SB-10056716-3131

Door Opens to First Stage While Driving

F15 (X5)

With option 323 (Soft Close)

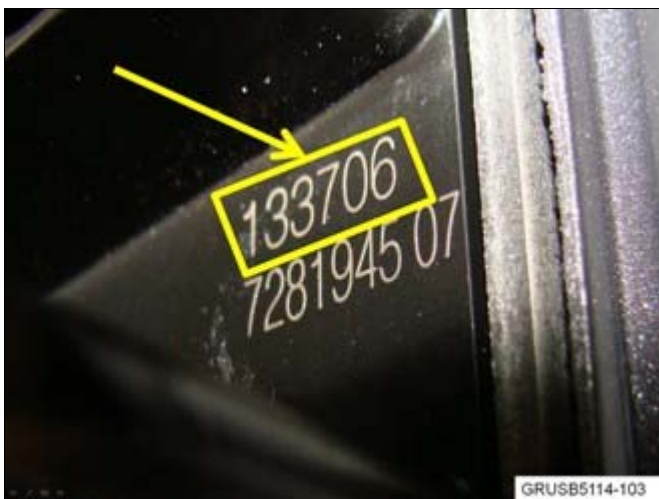
19. Remove the existing Bowden

cable cover from the lock and discard.

Modify the new Bowden cable cover by cutting off the guide tab (as shown) with a suitable tool (diagonal cutters, wiz wheel, etc.).

20. Note: The date code on the new Bowden cable cover must be 05 or higher.
